Delegated Report

Approval of Conditions Application

Application No:	20240511
Location:	Crabbles Cottage, Pear Tree Lane, Shorne, Gravesend, Kent, DA12 3JS
Description:	Application for the approval of conditions 3,4,5 and 6 attached to planning permission reference number 20240017 relating to the Bat Survey (3), Vehicular Access Track (4), Biodiversity Increase (5) and Lighting Design (6).
Applicant:	Mr Martin Tutty-Johnson

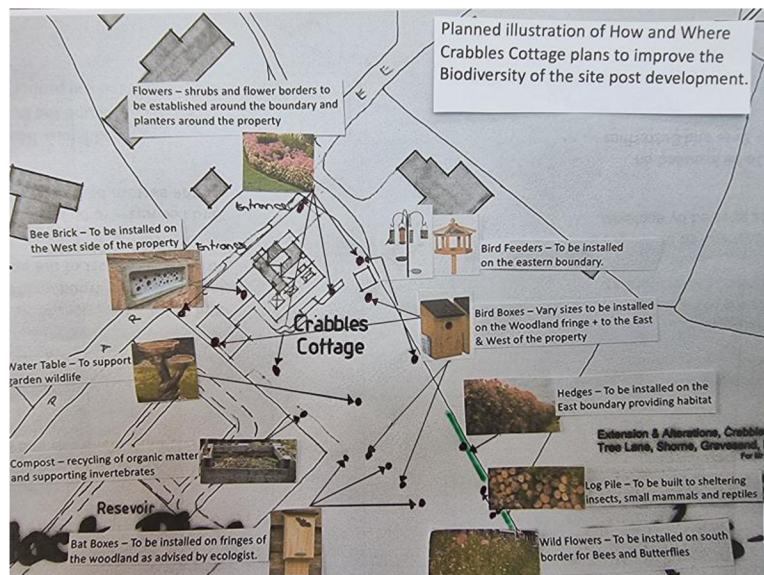
The supporting information confirms that the vehicular access track will be constructed using permeable paving grids (as shown in the image below).

The permeable grids will enable organic material and plants to grow through, which mitigates the potential urbanising impact of the access and is suitable for the rural setting. The information submitted is acceptable and condition 4 can be approved.

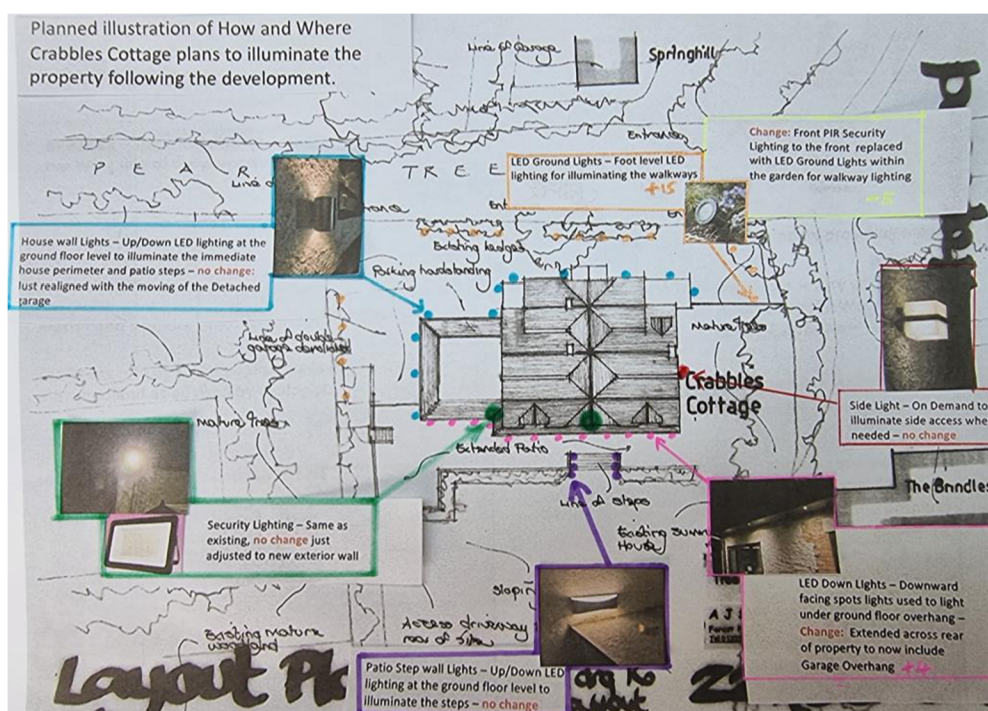
From looking at the submitted documents I would recommend conditions 1 (3) and 5 for discharge as all of the requested information is contained within the bat report & covering letter. However, the wording of condition 6 has not been satisfied. The lighting plan is difficult to read as it is a photograph of a hand-drawn map & it seems to indicate that over 30 external lights will be installed outside the property. The same symbol (a black dot) is used to indicate ground and security lights, so I can't tell which is which. You may wish to highlight that the lighting plan needs to demonstrate *"that areas to be lit will not disturb bat activity."* The current plan lacks any such detail.

Regarding Condition 6 (Lighting Design), the Parish Council is concerned that the amount of exterior lighting proposed may be excessive for a rural area and result in light pollution.

The Society is concerned at the level of exterior lighting proposed in a rural location. The coverage and level of luminance the lights would provide is not indicated. The Society is concerned at possible light pollution.

The revised details show that there will be minimal increase in lighting on the site. There will be 4no. additional downlights under the garage canopy, the existing 5no. PIR lights to the front will be replaced by 15no. micro soft-led ground walkway lights to the front of the dwelling. Other lights will be repositioned and reused.

The proposed lighting schedule is considered to be acceptable and would limit impacts on the character of the area and safeguard protected species by positioning lights close to the dwelling. Therefore, sufficient details have been submitted to approve condition 6.
